HVAC UPGRADES – PHASE 1

**ABRAHAM BALDWIN MIDDLE SCHOOL
68 BULLARD DRIVE
GUILFORD, CT 06437
BID #6-1819**

S/P+A PROJECT NO. 18.278

Date Issued: April 29, 2019

"TYPICAL" GUARDRAIL DETAIL

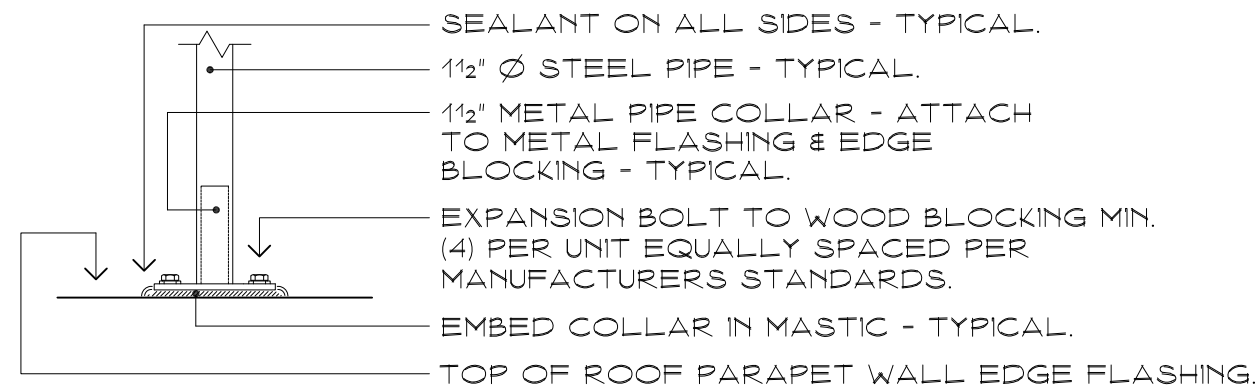
- DRAWING SKA1, ROOF DETAILS has been added and is attached as part of this addendum.
- DRAWING SKA2, REVISED DOOR SCHEDULE has been added and is attached as part of this addendum. This sketch revises information on Drawing M-5C.

CONDUIT CURB DETAIL

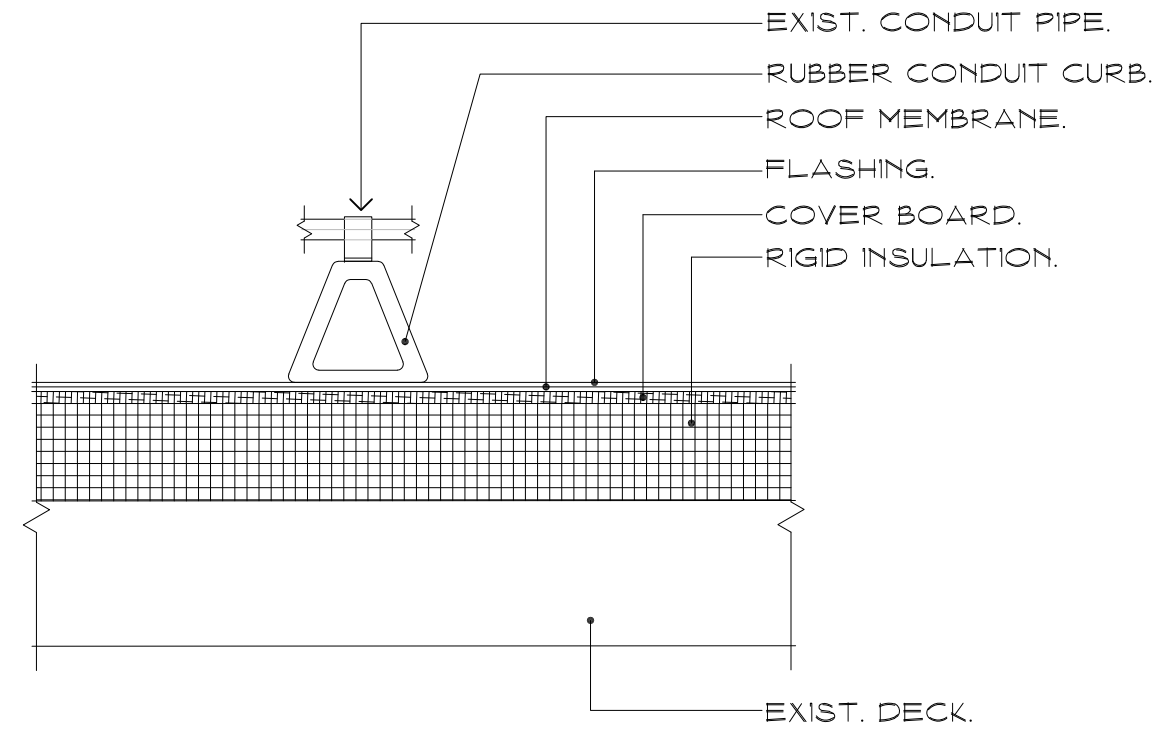
PROVIDE ECOCURB REC 9S AS MANUFACTURED BY ADVANCED SUPPORT PRODUCTS OR EQUAL AT 10' O.C. UNDER PIPING SHOWN ON DRAWING M-3.1C.
